PLANNING COMMISSION AGENDA

Title: Public Hearing - Conceptual Site Plan (amended), 335 South Frontage Road, Miles Bell LC, Applicant David Bell - ADMINISTRATIVE DECISION

UT183-CF | 04:32 PM THURSDAY 22 JUNE 2023 | P:\2023-0103 AIDEN BELL-DAVES COMPLETE AUTO IMPROV.DRAWINGS\SHEETS\CS101.DWG

Title: Public Hearing - Conceptual Site Plan (amended), 285 South Frontage Road, Aiden Bell LC, Applicant David Bell - ADMINISTRATIVE DECISION

1 8' CMU WALL
NOT TO SCALE

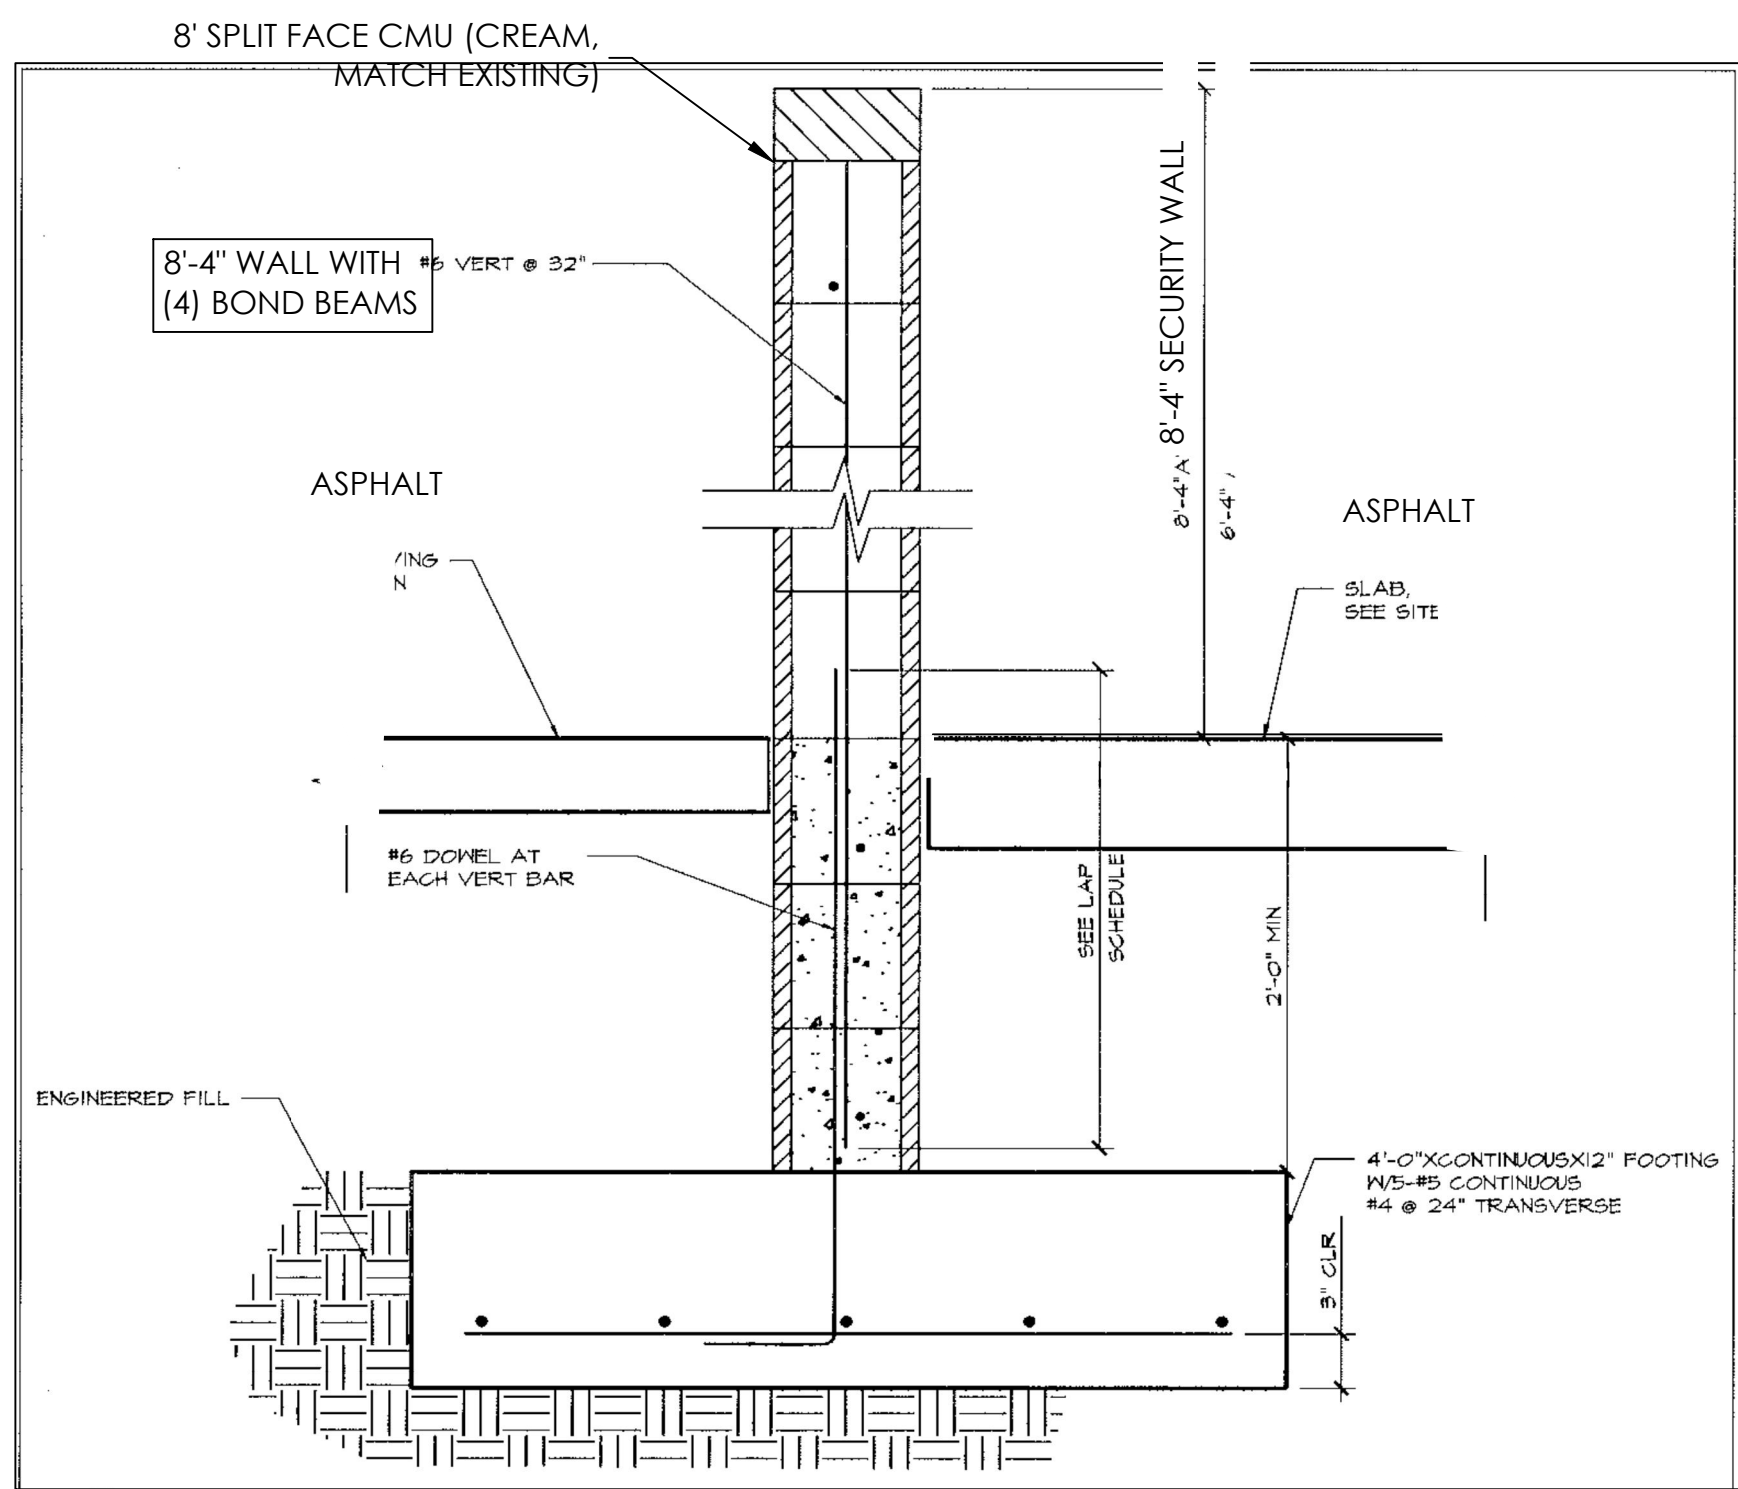
- **Fences and Walls** – The Zoning Code limits fence and wall heights to 6 feet or less as a permitted allowance for the site. However, at the discretion of the Planning Commission, the site may be approved with a wall or fence up to 10 feet, if it is determined by them to be a benefit to the surrounding properties and/or help to buffer the use and is in the City's best interest. Please provide a narrative or illustrative argument for the reasoning to install a taller fence and submit this with your site plan application. (**Fence/Walls Depicted, Narrative/Illustrative Argument not Provided**)
